Taking the Easy Path...

The Glitch:

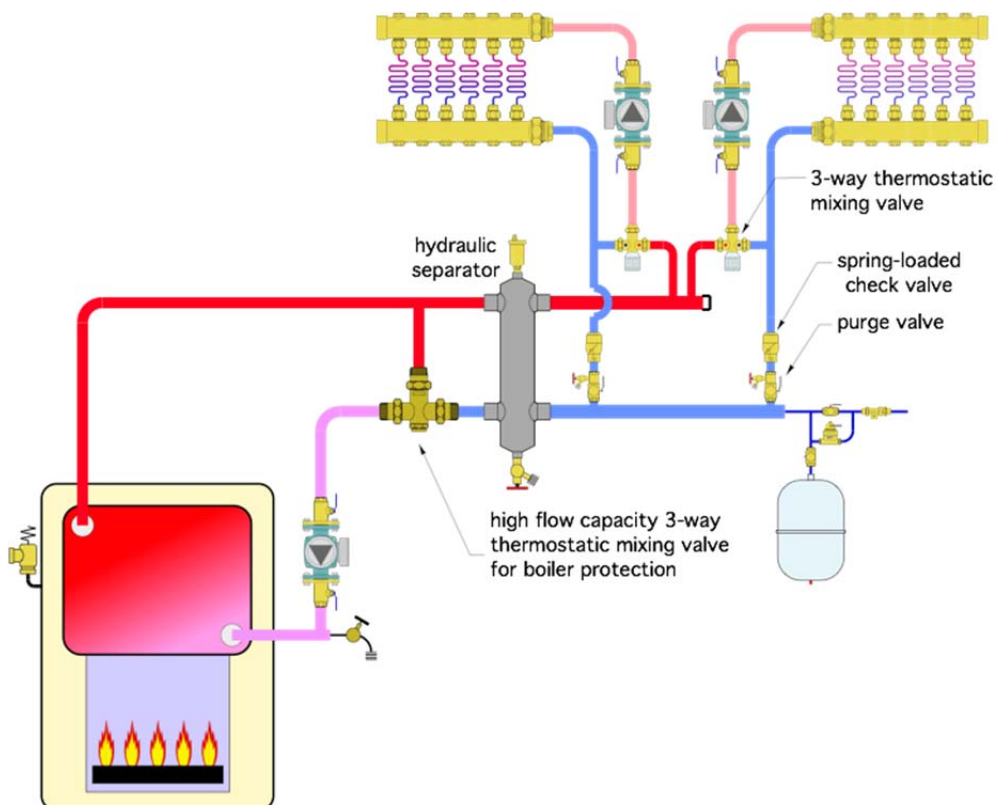
An installer pipes up a 2-zone low-temperature radiant floor heating system to a conventional gas-fired boiler as shown in Figure 1. Zone valves are installed so that each zone can operate independently. Can you identify at least 4 errors in this design?

1. Whenever there's a mixing valve in a hydronic distribution system there has to be a circulator between that mixing valve and the heat emitters. This is not the case in the glitch drawing. Remember: When flow exits a circulator all it "cares about" is getting back to the inlet of that circulator. In the glitch drawing there is virtually no "incentive" for flow to pass through the radiant panel manifold stations, even when the zone valves are open. Instead, it takes the short cut from the hot port to the cold port of the thermostatic mixing valves. This is sure to lead to an underheating problem.

2. There is nothing to prevent sustained flue gas condensation from forming within the conventional boiler. There are several ways to fix this, each of which measures the water temperature entering the boiler and reacts to it. One of the simplest approach is to install a high flow capacity 3-way thermostatic mixing valve as shown in figure 2. This valve will always modulate in an attempt to keep the boiler inlet temperature at or above 130 °F, which is generally high enough to prevent sustained flue gas condensation.

3. Because each of the manifold stations now has its own circulator, each can operate as a separate zone. However, this requires preventing of flow reversal through the inactive zone when the other zone is operating. A 3-way thermostatic valve cannot provide flow reversal protection, because under certain conditions flow can move directly between the hot and cold ports of the valve. This potential flow short circuiting also prevents a spring-loaded check valve within each of the new circulators from ensuring there is no flow reversal. The solution is to install a spring-loaded check valve near the end of each branch circuit. Provide at least 12 pipe diameters of straight pipe upstream of this check valve to minimize turbulence and possible rattling of the valve's internal disc.

4. Finally, the system in figure 1 lack any means of forced-water purging. Two purging valves, one in each branch circuit, have been installed in the system of figure 2 to handle this task.

The fix is to install a circulator between each mixing valve and its associated manifold station as shown in Figure 2. Eliminate the zone valves. The hydraulic separator is also used to minimize interaction between these new circulators, as well as between them and the boiler circulator. It also provides high efficiency air and dirt separation for the system.
